**2012 Errata to the  
2009 Thurston County Drainage Design and Erosion Control Manual  
August 2012**

## C. 2009 DDECM ERRATA No. 1

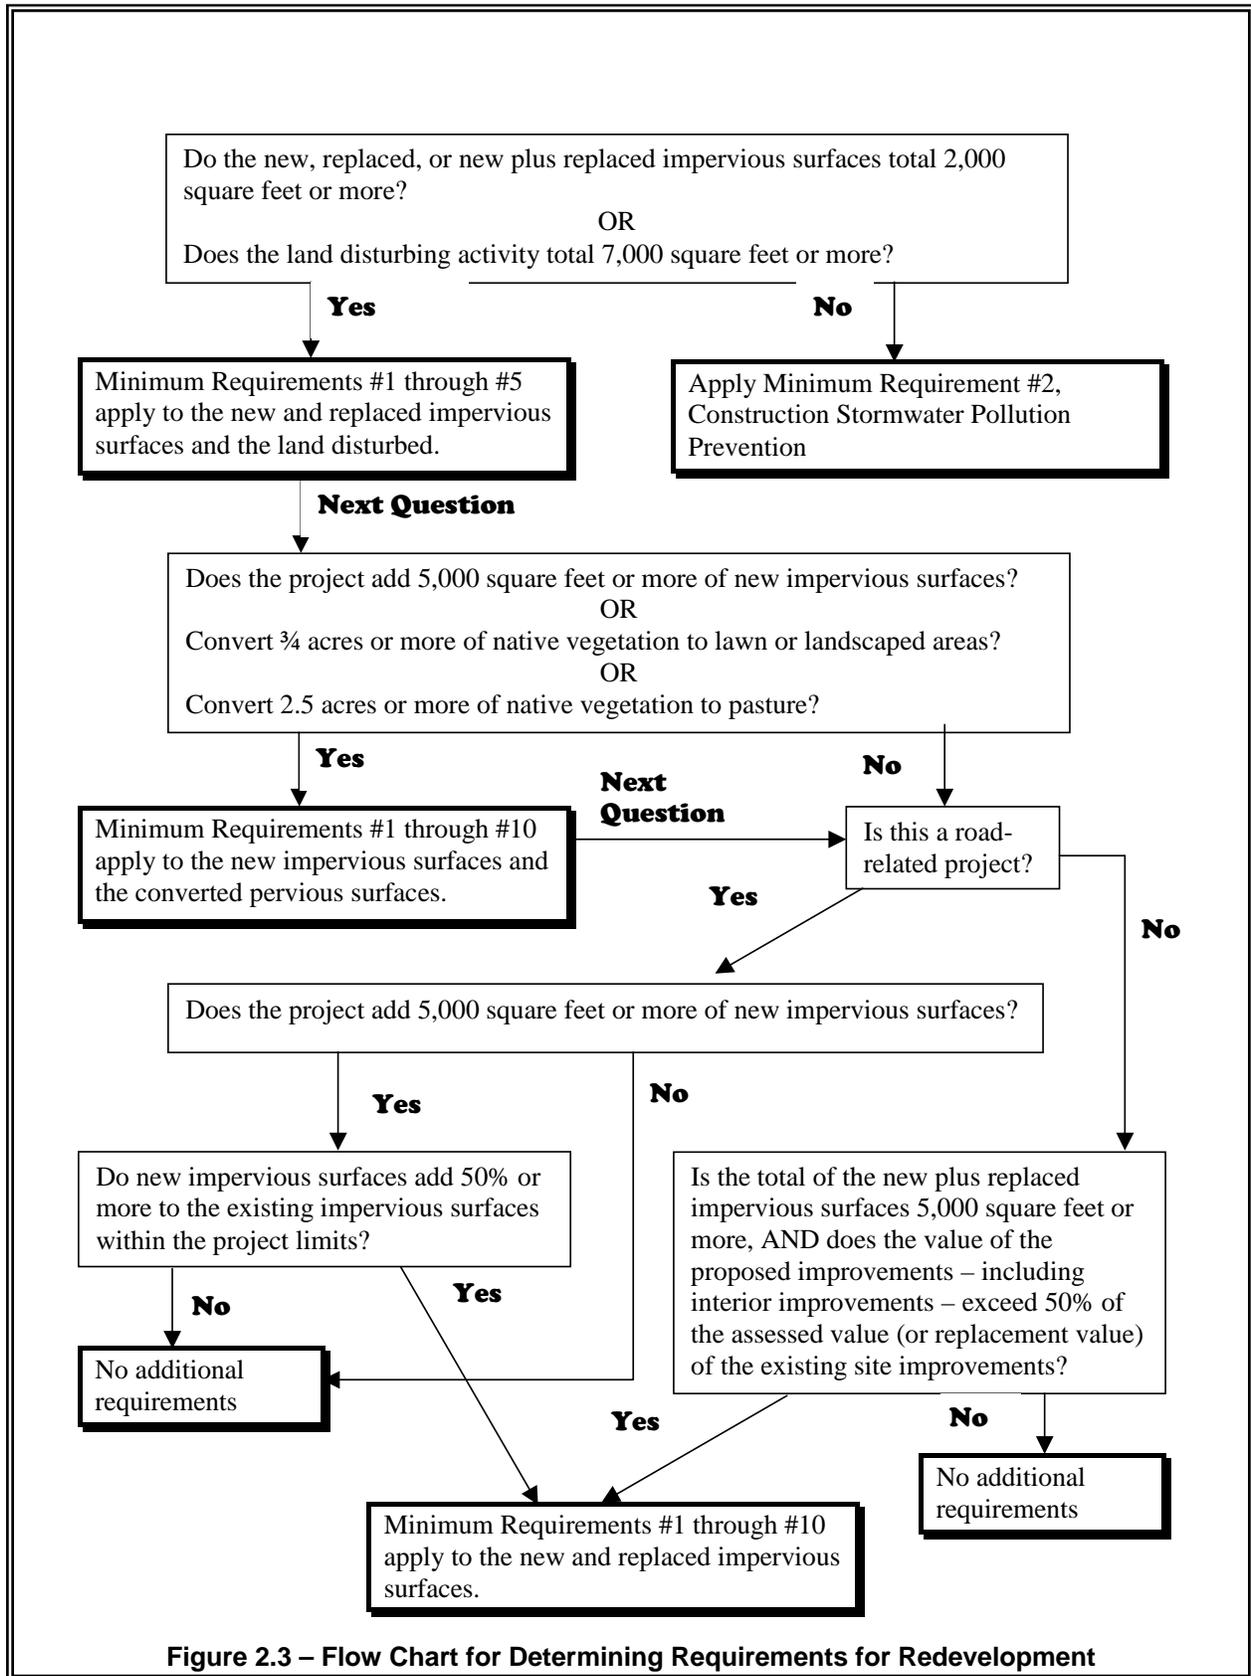
| VOL | SECTION   | PAGE NO. | DESCRIPTION & REASON FOR CHANGE   | CORRECTED TEXT (UNDERLINED = NEW TEXT, STRIKEOUT = DELETED TEXT)  |
|-----|---|----------|---|---|
| I   | 2.3<br>Applying Minimum Requirements:<br>Figure 2.2 | 2-6      | Amend Figure 2.2 to be consistent with requirements of Ecology SWMMWW related to when replaced impervious surfaces are required to comply with all minimum requirements.  | Add a footnote to Figure 2.2 that states the following: <b><u>“For redevelopment projects that are not required to apply minimum requirements #1 through #12 to all impervious surfaces applicant shall also determine whether all minimum requirements apply to replaced impervious surface using Figure 2.3 – Flow Chart for Determining Requirements for Redevelopment of the Ecology Stormwater Management Manual for Western Washington (2005), Volume I, Page 2-10. Where the Ecology’s figure 2.3 requires Minimum Requirements #1 through #10 this shall be interpreted as requiring Minimum Requirements #1 through #12 of the Thurston County DDECM.”</u></b> A copy of the flow chart is attached to this Errata Sheet.  |

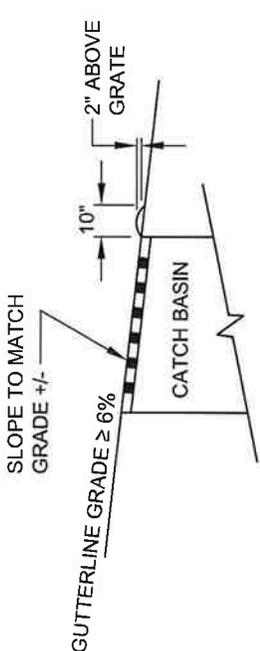
| VOL | SECTION                                       | PAGE NO.           | DESCRIPTION & REASON FOR CHANGE   | CORRECTED TEXT (UNDERLINED = NEW TEXT, STRIKEOUT = DELETED TEXT)   |
|-----|---|--------------------|---|--|
| V   | 2.2.5 LID.08<br>Bioretention Facilities       | 2-47<br>Figure 2.8 | Correct minimum width in Figure 2.8 to correspond to minimum width described in text (page 2-55)  | In Figure 2.8, Change the bottom width dimension to read: “2’ MIN” instead of “3’MIN”  |

CONCRETE CURB CATCH BASIN INLET DETAIL

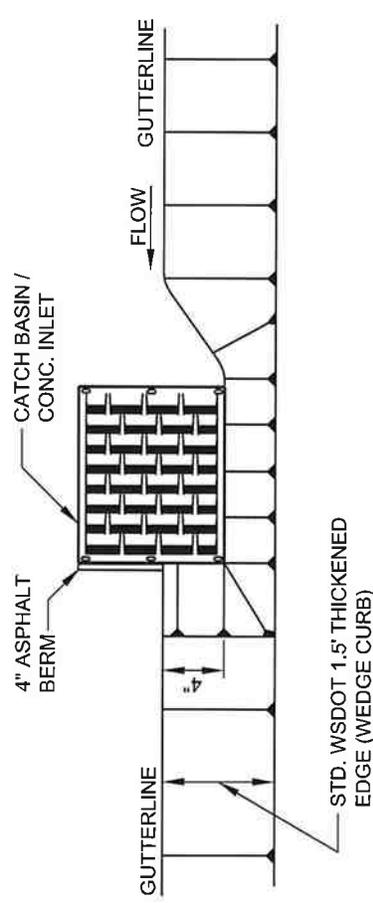
| VOL                               | SECTION  | PAGE NO. | DESCRIPTION & REASON FOR CHANGE  | CORRECTED TEXT (UNDERLINED = NEW TEXT, STRIKEOUT = DELETED TEXT)  |
|-----------------------------------|--|----------|--|---|
| III                               | 3.7.7<br>Pipe Structure Criteria                                   | 3-15     | In section “ <i>Catch Basins and Manholes</i> ” the second to last paragraph on page 3-15 references a detail that is not included in the DDECM. The correct detail is from the Pierce County Stormwater Manual – Detail 10.0 of Attachment A. A copy of this detail is attached to this Errata. | Amend the second to last paragraph of this section to read as follows: “When the road profile equals or exceeds 6 percent between structures, an asphalt berm shall be installed around the inlet of the structure or the catch basin may be recessed into the curb per <u>detail 10.0, Grate Detail for Steep Slopes, of Attachment A to the Pierce County Stormwater Management and Site Development Manual</u> <del>this detail.</del> ” -- [note: a copy of this detail is attached to this errata or can be found on the Pierce County web-site]   |
